# INITIAL FIRE SAFETY INSPECTION REPORT

## Amtranet Limited (New Buildings 2)

RSC ID: 24776

Date: 14-Dec-2023

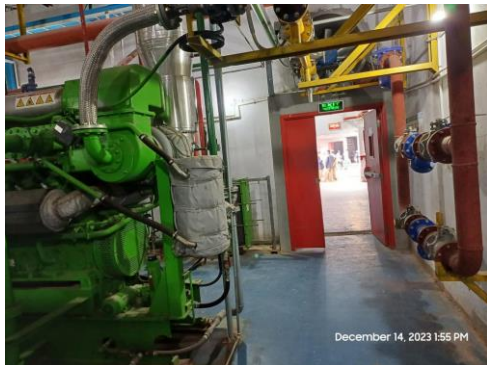
F-2	Fire Rated Construction	<p>Storage and Generator rooms discharge directly into the exit stair enclosure.</p> <p><b>Location:</b> Building-4, Ground Floor Utility Building, Ground Floor</p>	<p>Openings from exit enclosure to storage and machine room spaces shall be provided with a vestibule with fire rated construction and openings.</p> <p><b>For 3 story or below;</b> Provide a 1 hr. fire rated door on the exit stair side and a 1-hr. fire rated door on the storage and generator room side. Ensure that the fire rating of the vestibule construction matches that of the exit stair enclosure.</p> <p><b>For 4 story or more;</b> Provide a 2 hr. fire rated door on the exit stair side and a 1.5 hr. fire rated door on the storage and generator room side. Ensure that the fire rating of the vestibule construction matches that of the exit stair enclosure.</p>	Within 3 months
-----	-------------------------	--	---	-----------------

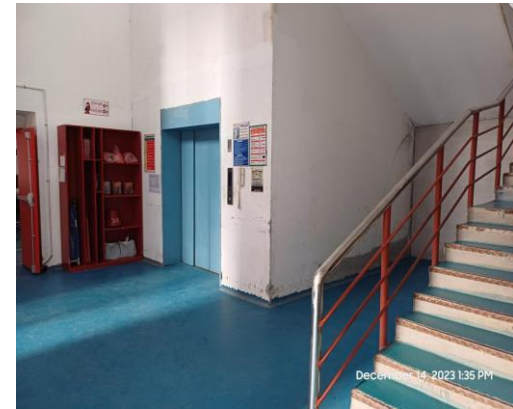
F-3	Fire Rated Construction	<p>Elevator shafts are directly open into the inside of exit enclosure.</p> <p><b>Located:</b> Building-3 Building-4</p>	<p>An exit stairway shall not be built around a lift shaft unless both of them are located in a smoke proof enclosure and made of a material with fire resistance rating required for the type of construction of smoke proof enclosure.</p> <p>Modify the elevator shaft as per The RSC Technical Guideline (Standard) V1-6.14.3.Rearrange the facility to provide separate enclosure for lifts. If not possible anyway provide a minimum 2-hr fire- rated elevator shaft with listed fire rated lift landing door to separate from each floor level.</p>	Within 3 months
-----	-------------------------	--	--	-----------------

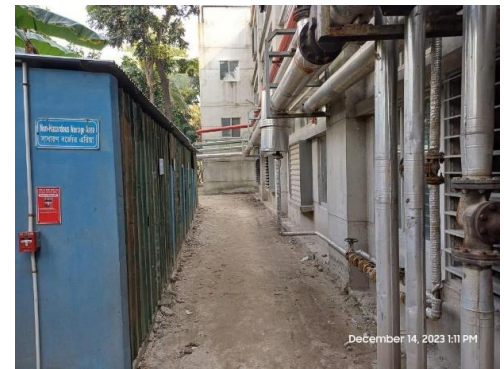
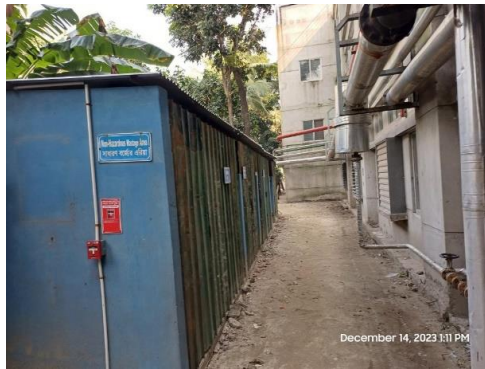
F-5	Fire Rated Construction	<p>Chemical storage area is not separated by fire-rated construction having non rated door and unsealed penetrations and openings in exit stair.</p> <p><b>Location:</b> B#2: Building-4, Ground Floor.</p>	<p>Separate the Chemical Storage area by a minimum 4-hr fire-rated construction. Seal and/or protected all openings to maintain the required fire separations. Follow 2.13 of BNBC-2006. For the case of 4-hr fire separation no opening is permitted.</p>	Within 3 months
 <p>The images show a chemical storage area with blue barrels arranged in rows. The first image shows a view through a glass partition into a room with blue barrels. The second image shows a long aisle with blue barrels on both sides. The third image shows a close-up of blue barrels with a white label.</p>

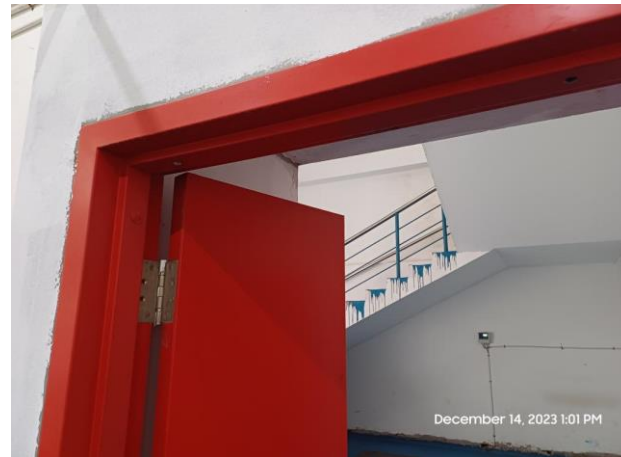
F-10	Fire Rated Construction	<p>Installed fire doors throughout the factory were not swinging and closing properly due to inappropriate installation of door accessories (closer, coordinaator, holding devices etc.).</p>	<p>Ensure that the fire doors are self-closing and positive latching and that they are provided with fire exit panic hardware where serving production floors. If fire doors are required to be held open for functional reasons, provide automatic closing devices tied to the fire alarm system.</p> <p>The clearance under the bottom of a fire door shall be a maximum of 3/4 in. (19 mm).</p>	Within 1 month
------	-------------------------	---	--	----------------
